# WATER QUALITY MEMORANDUM

SUBJECT: 2009 Second Quarter Water Monitoring, CW Mining Company, Bear Canyon Mine, C/015/0025, Task ID # 3334

Lower Right Fork Bear Creek (BC-3)

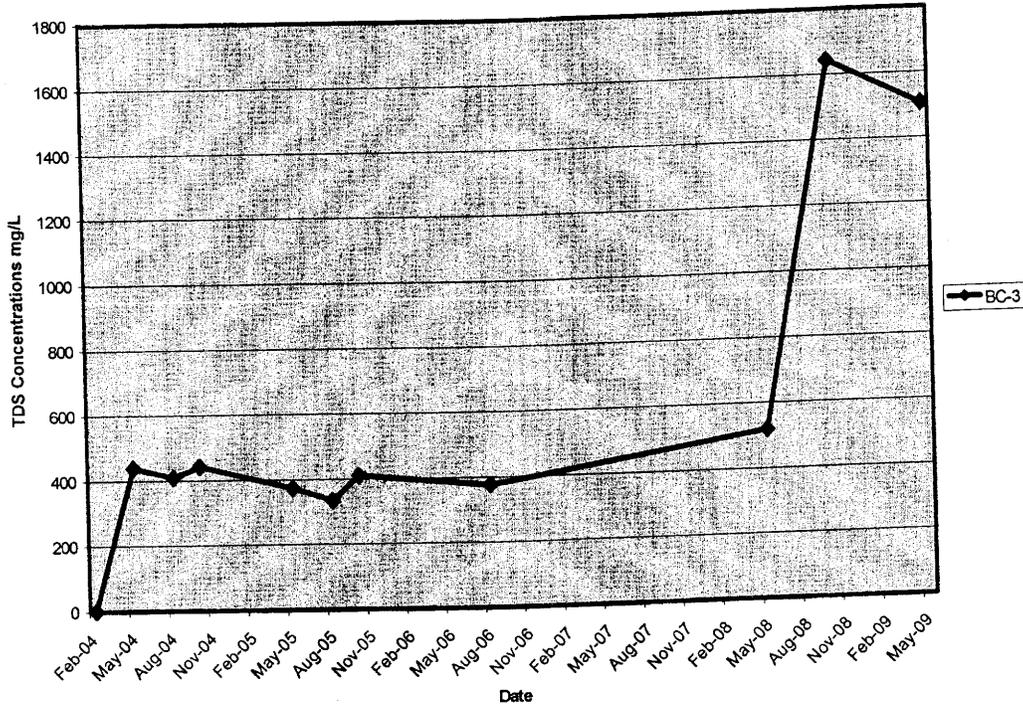
Sample BC-3 at the Lower Right Fork of Bear Creek has shown a recent increase in the levels of Total Dissolved Solids (TDS) since Fall 2008. Prior to this increase, TDS levels have averaged around 400 mg/L since 2004 (see chart below). Other water quality parameters such as dissolved calcium, dissolved potassium, hardness, sulfate and others were also outside of two

standard deviations during the October 2008 and May 2009 sampling.

- Sample BC-3 at the Lower Right Fork of Bear Creek has shown a recent increase in the levels of Total Dissolved Solids (TDS) since Fall 2008. This indicates that excess sediment may be discharging into the creek. The operator should evaluate sediment controls in this area and determine if there is any mitigation needed to control the level of sediment entering the water body.
- UPDES Sample 004 exceeded the 30-day average discharge limitation of 500 mg/L for TDS during May/June 2009. More data points are recommended to be collected within the 30-day period to determine if UPDES compliance point 004 is meeting effluent standards.
- Depth to water levels (75-78 feet) reported in wells SDH-2 and SDH-3 is questionable when previous data have shown that the groundwater surface averages approximately 1,500 feet below well casing. These measurements should be reevaluated to determine an
